APPLICATION NO.	FILING DATE	FIRST NAMED INVENTOR	ATTORNEY DOCKET NO.	CONFIRMATION NO.
10/541,281	02/03/2006	Gerrit Jan Nieuwenhuis	MULLE45.001APC	6247
20995	7590	11/26/2007	EXAMINER	
KNOBBE MARTENS OLSON & BEAR LLP			BUI, LUAN KIM	
2040 MAIN STREET			ART UNIT	PAPER NUMBER
FOURTEENTH FLOOR			3728	
IRVINE, CA 92614

**Advisory Action  
Before the Filing of an Appeal Brief**

FOIL BAG PROVIDED WITH A PUNCHED OPENING AND  
INCISIONS  
Gert Jan Nieuwenhuis  
Appl. No.: 10/541,281 Atty/Court: MULLE/5.001 APC  
REPLACEMENT SHEET

FIG. 1A

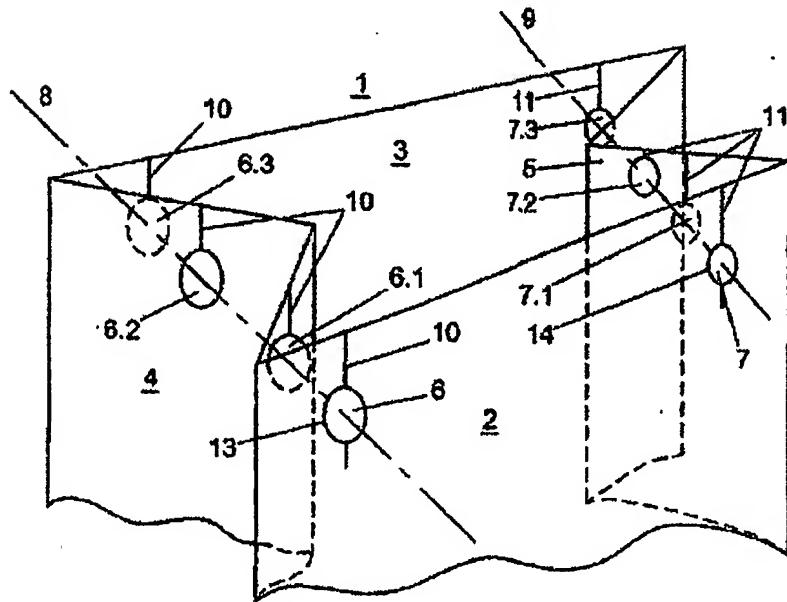
The proposed drawing correction in Figure 1A, filed on 11/6/2005 have been disapproved because Applicant is required to extend the incisions (10 and 11) beyond the lower circumferential edge for each opening (6, 6.1-6.3, 7, 7.1-7.3) not just two openings 6, 7.
